Service Bulletin #38

To: Service Managers  
From: Data East Pinball Service Department  
Date: August 14, 1992  
Subject: Typographic error on the New Power supply  
Schematic 520-5047-01

DATA EAST PINBALL  
 POWER SUPPLY BOARD SCHEMATIC

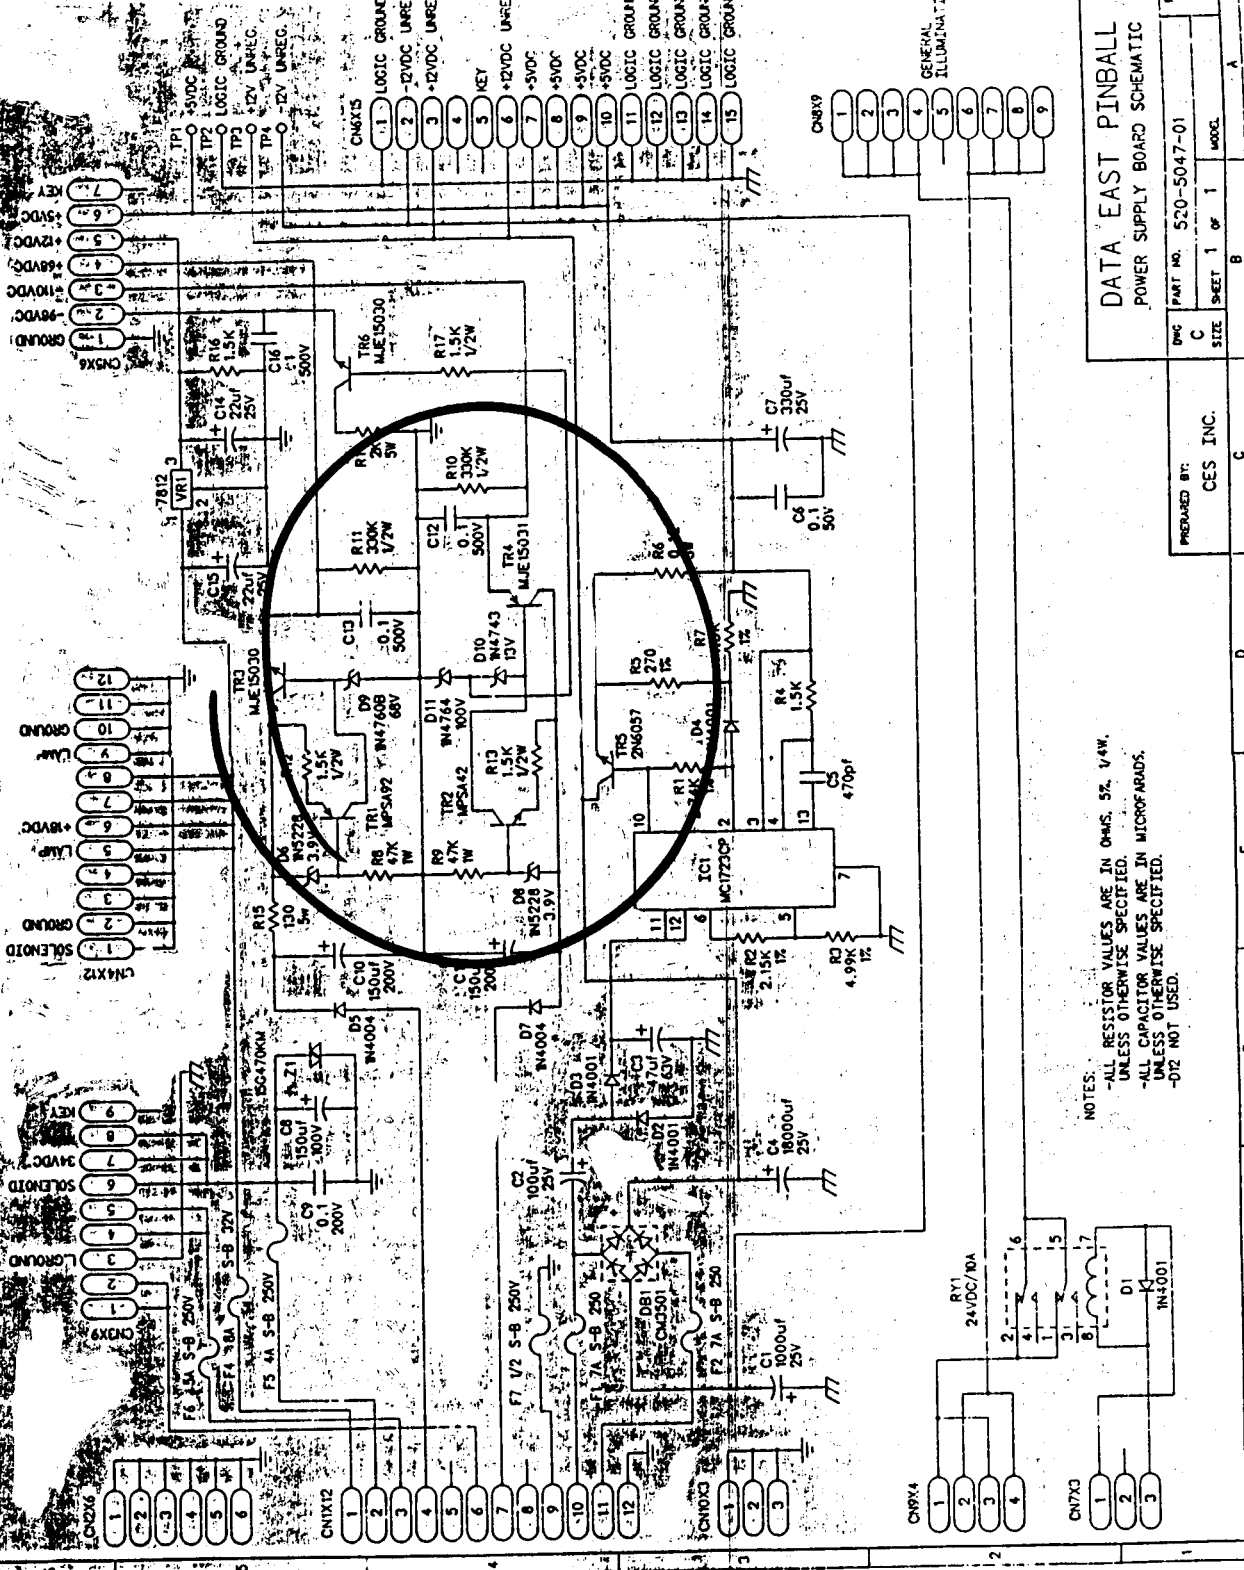
The diodes D10 and D11 on the REV A schematic for the Power Supply 520-5047-01 used in Lethal Weapon 3 have been mislabeled. Please see the attached drawing (REV B) for the correct location of these diodes.
